REPORT BY THE  
AUDITOR GENERAL  
OF CALIFORNIA

**A REPORT ON AN AUDIT  
OF SECURITY MEASURES  
AT TWO CALIFORNIA PRISONS**

March 14, 1986

Arthur Young & Company is pleased to submit this report on our Audit of Security Measures at Folsom State Prison and two units of the California Institute for Men (CIM) -- CIM-Reception Center Central and CIM-East. This report is organized as follows.

# Recommended Inmate Movement Route

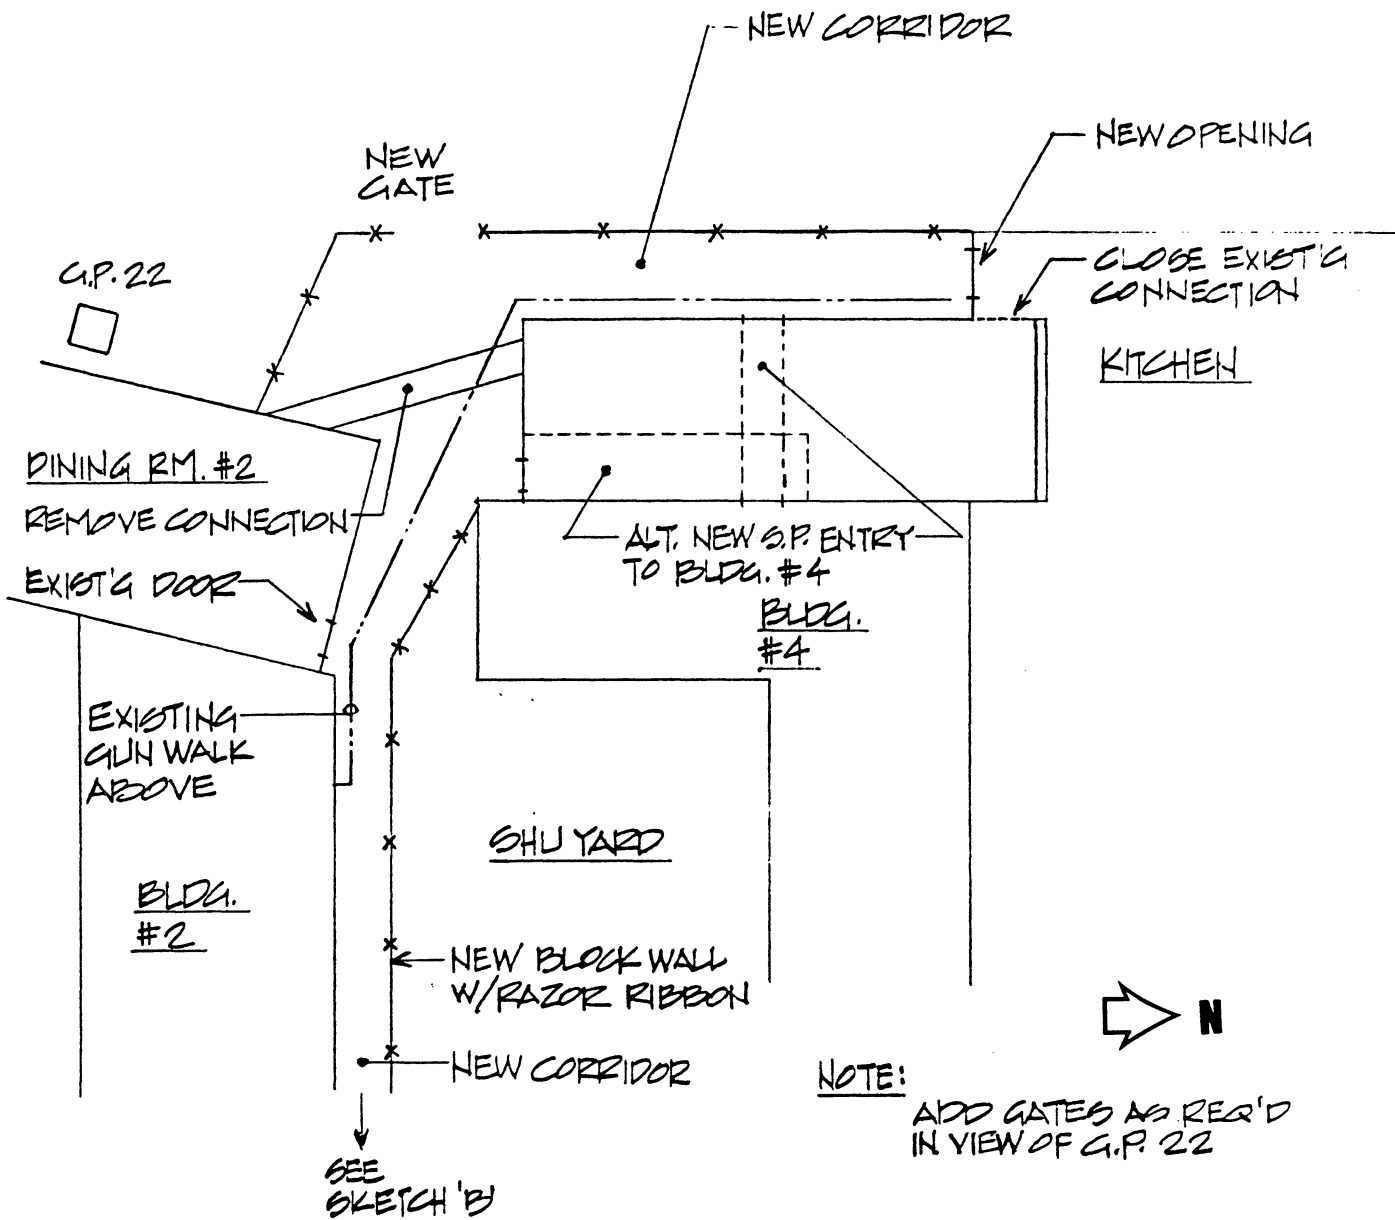
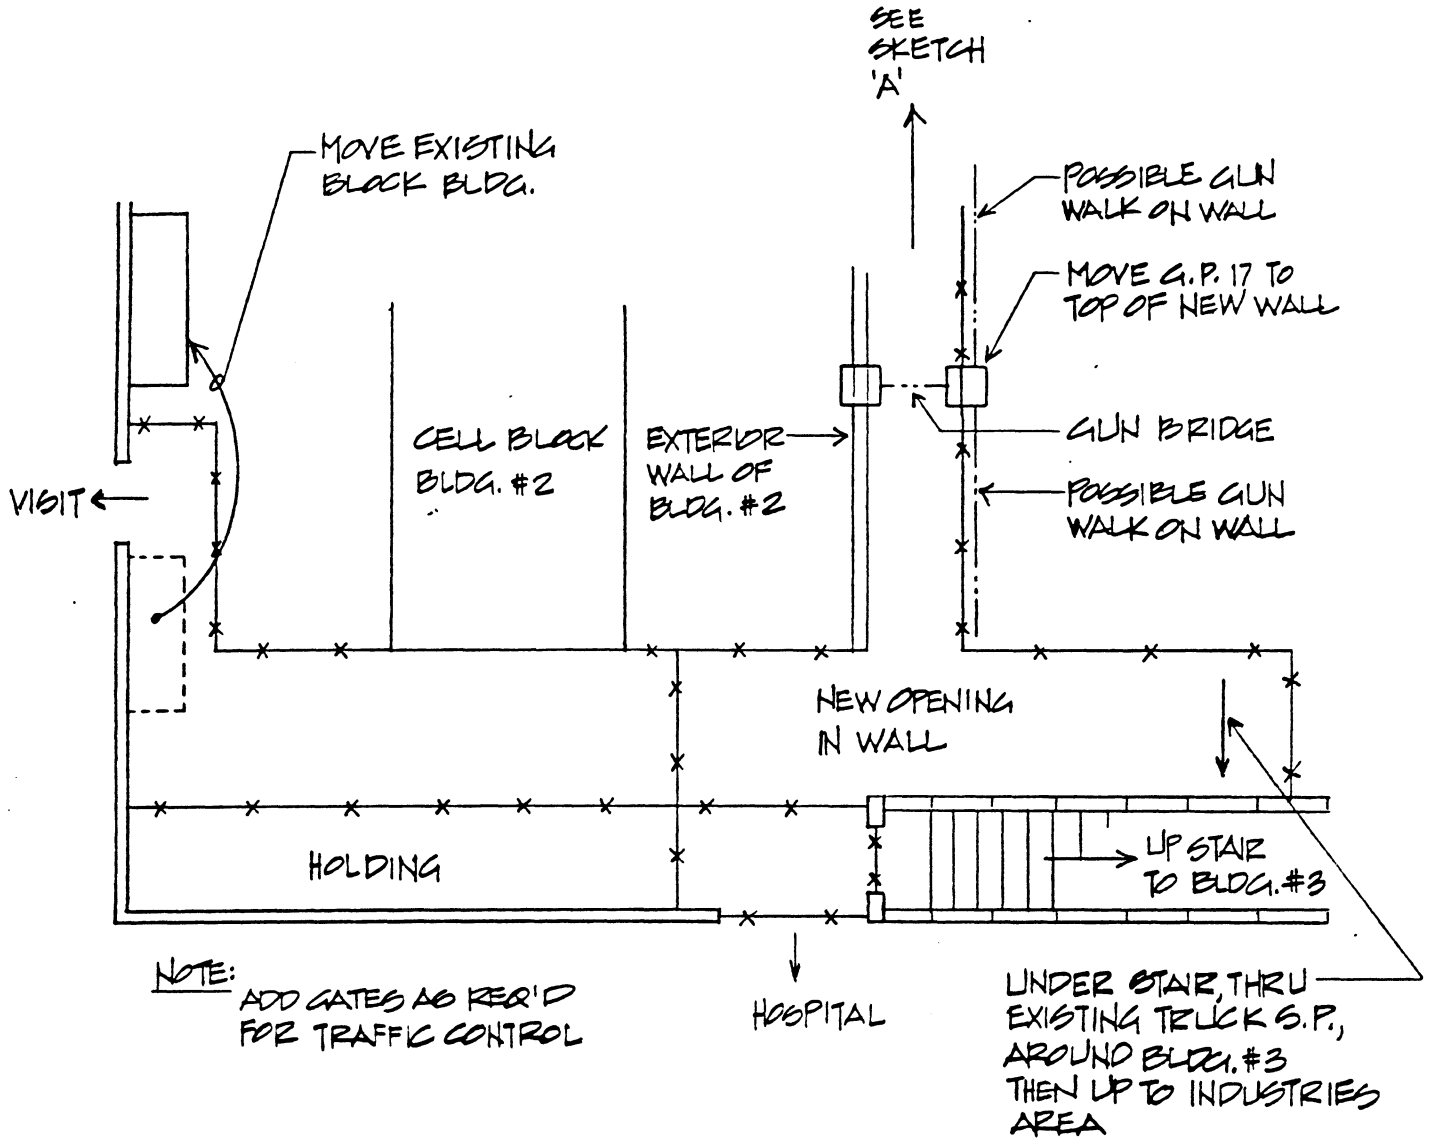
Recommendation FSP No. 2: Modify Folsom facilities to improve inmate movement and segregation, and to establish housing unit integrity.

Exhibit VI-1, on the next two pages, presents diagrams of recommended modifications to the current prison movement routes that was prepared by our subcontractor, MW Consulting Engineers. The diagram displays a new movement path from the Main Yard to the Hospital corridors. Inmates proceeding

Shortly after entering the proposed corridor from the Main Yard, there is an existing unused door that, if opened, would provide entry to Dining Room #2 near the serving lines. The fence and gate inside this door divides the Dining Room corridor from the rest of the dining area. This fencing should be modified so that the door from the new path would allow entry to the corridor and not the Dining Room.

An alternative is to maintain the #5 count gate and have it provide the only entry/exit point for inmates living in Building #5 (except for the current mealtime routing into Dining Room #2). This alternative eliminates traffic in the Dining Room corridor, but would require another post for the new Main Yard gate leading to the new inmate corridor.

We believe implementation of the recommended re-routing, or another version that accomplishes the same purpose, will add substantially to contraband control, inmate control, and integrity of the general housing units. It will provide direct routes to and from each housing unit, and improved monitoring of who is in each housing unit.

# Recommended Layout for SHU Visiting

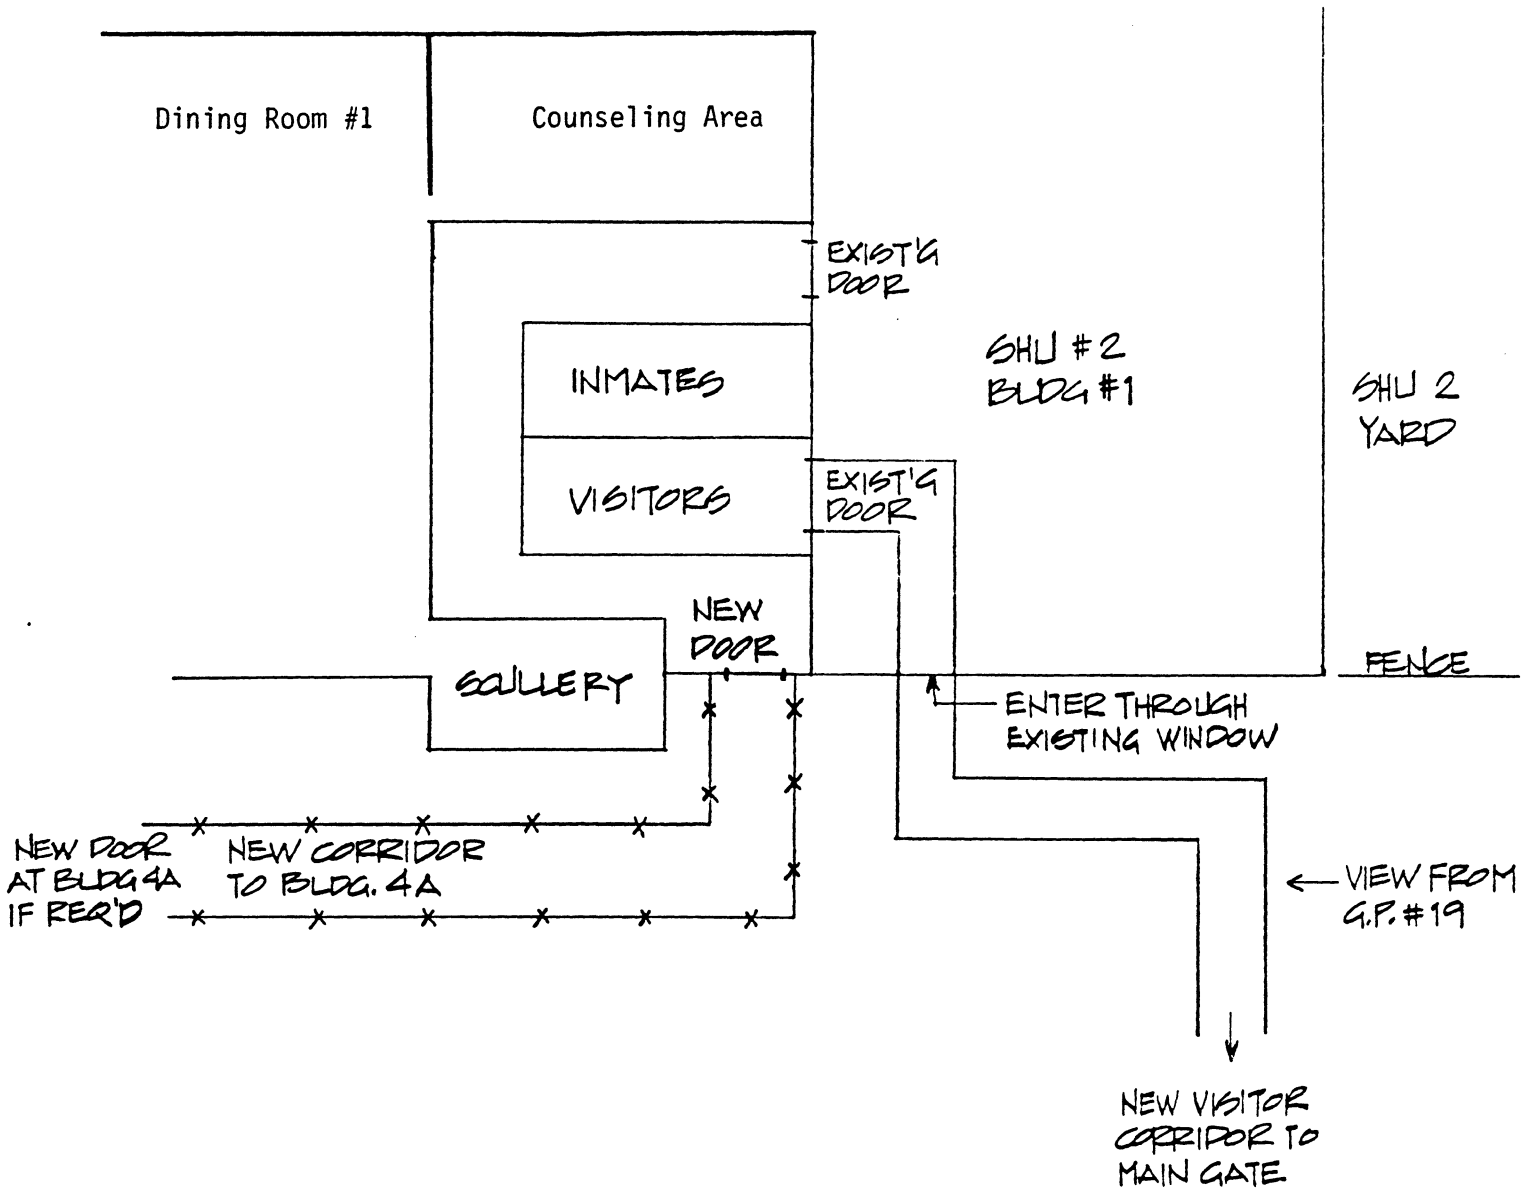
Exhibit VI-2 provides an example of how this recommendation might be implemented. The modifications necessary to accomplish this change are outlined below:

Under the preceding approach, counseling and committee hearings for SHU inmates would occur in the modified Dining Room #1, as would non-contact visiting. This plan is not without problems, especially in constructing an appropriate bridge or four-way sallyport where the visitor path would cross the current inmate path to Prison Industries. The overwhelming majority of inmate traffic to and from Industries occurs only twice a day. Perhaps other arrangements could be made for the few inmates who return during the work day.

Additionally, prison management is considering the use of Dining Room #1 for general population inmates because it now takes three to four hours to feed all of them in Dining Room #2. If this change is instituted, and if Building #1 continues to be operated as a SHU, then alternatives would be to (1) construct a new, separate SHU visiting and counseling building just north of Building #3, (2) remove a significant number of first tier cells in SHU II (east end) and convert the space to visiting and counseling use, or (3) add to the east end of SHU II for this purpose.

# Proposed Location of Lower Yard Custody Office

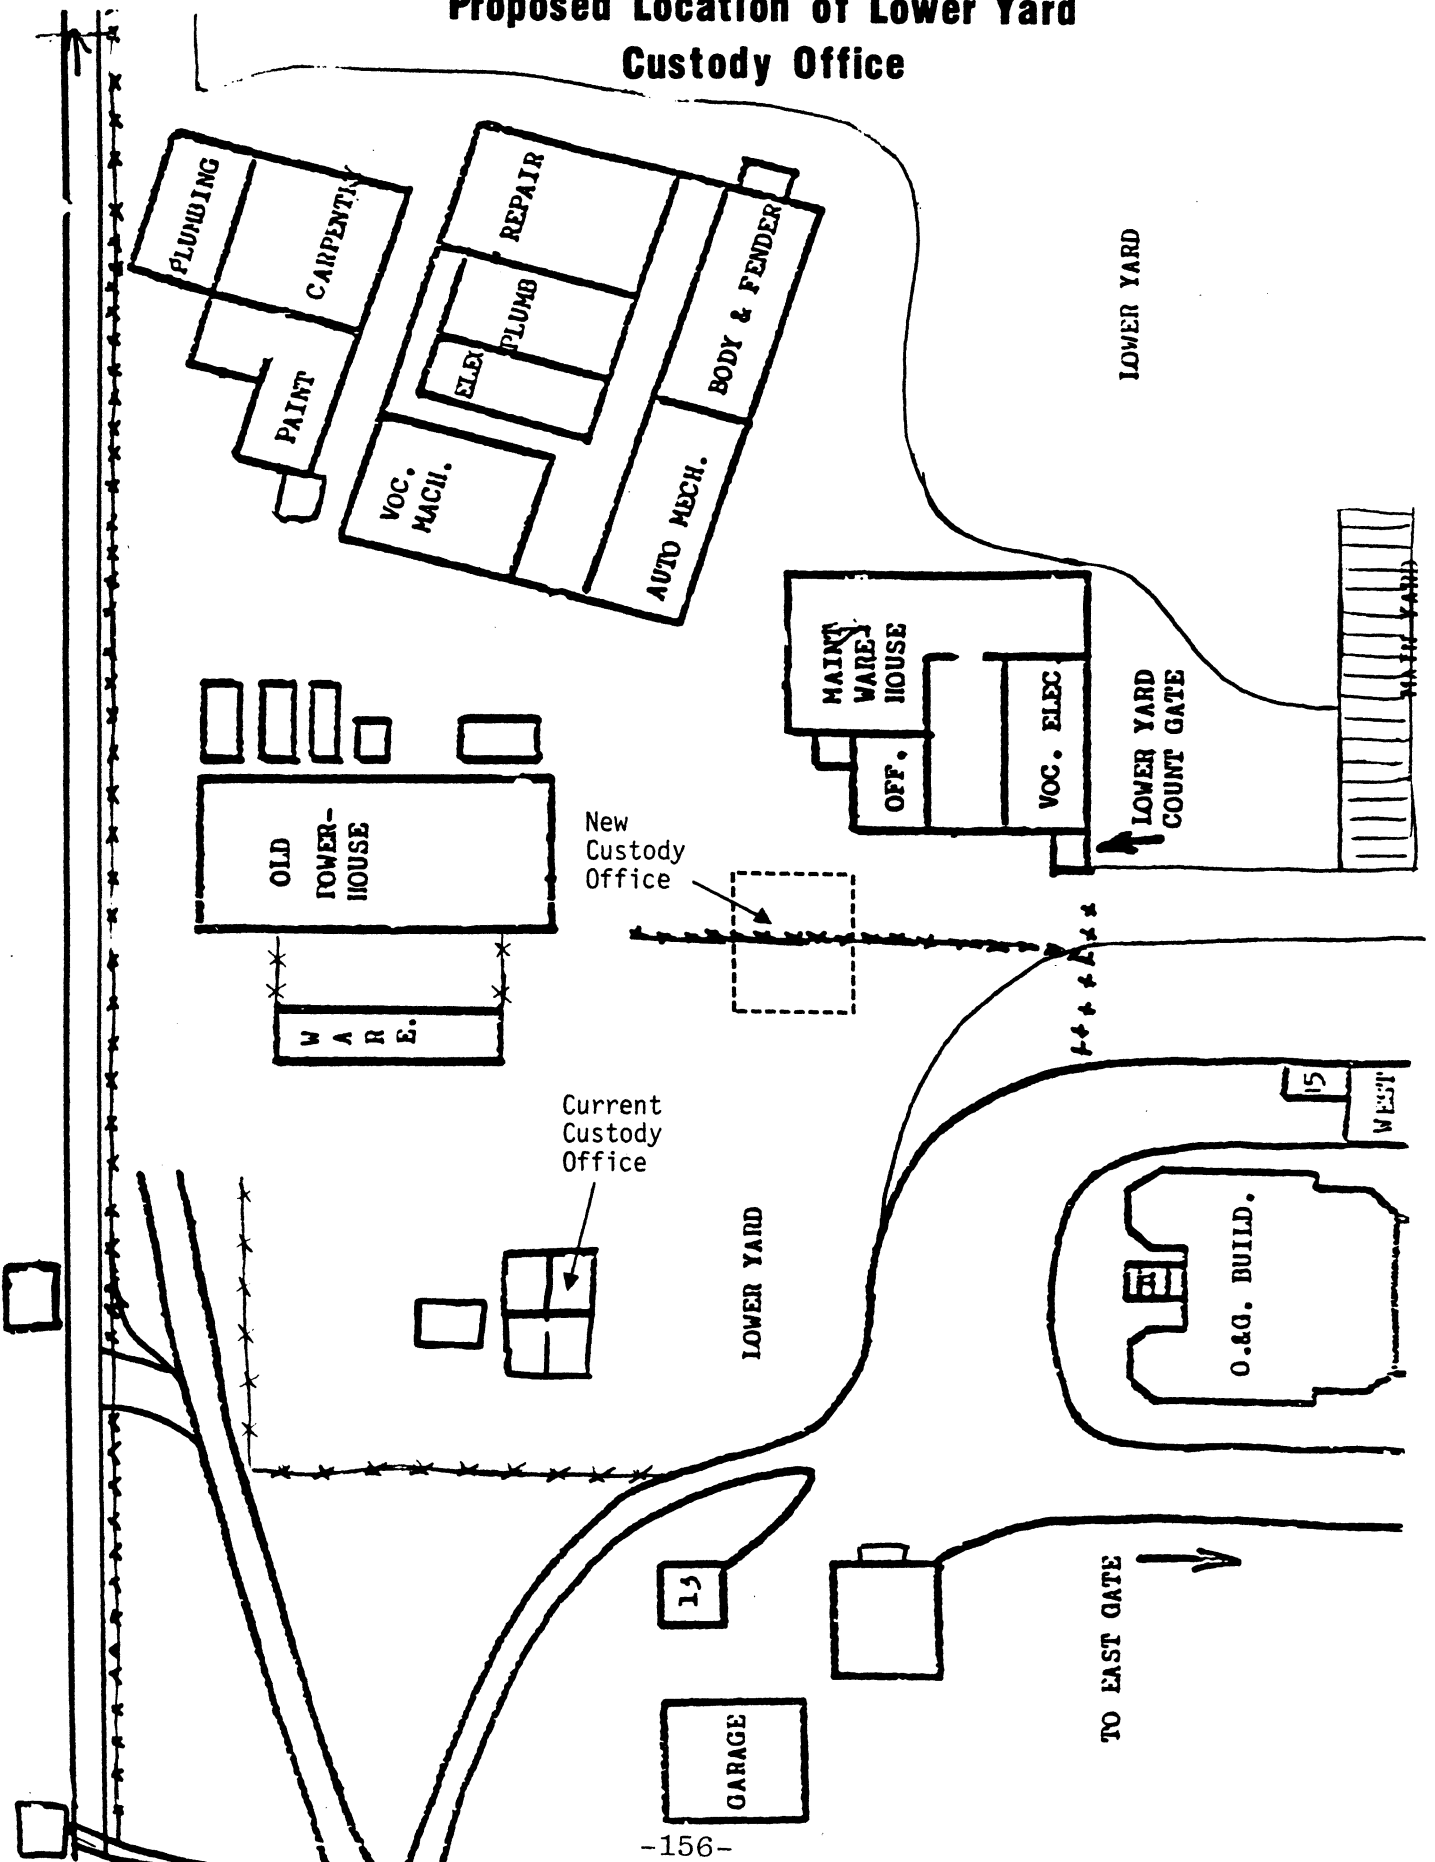
Recommendation FSP No. 24: Relocate the Lower Yard custody office to a point across from the count gate.

Exhibit VI-3 depicts the recommended position for relocation of the Lower Yard custody office. In this new location, inmates can be viewed entering and leaving the primary Vocational buildings, and while they are in the yard. Moreover, access to the various buildings can be controlled from this location. We estimate the cost of materials to construct a 600 sq. ft. custody office at less than \$10,000. Inmate labor can be used for the construction.
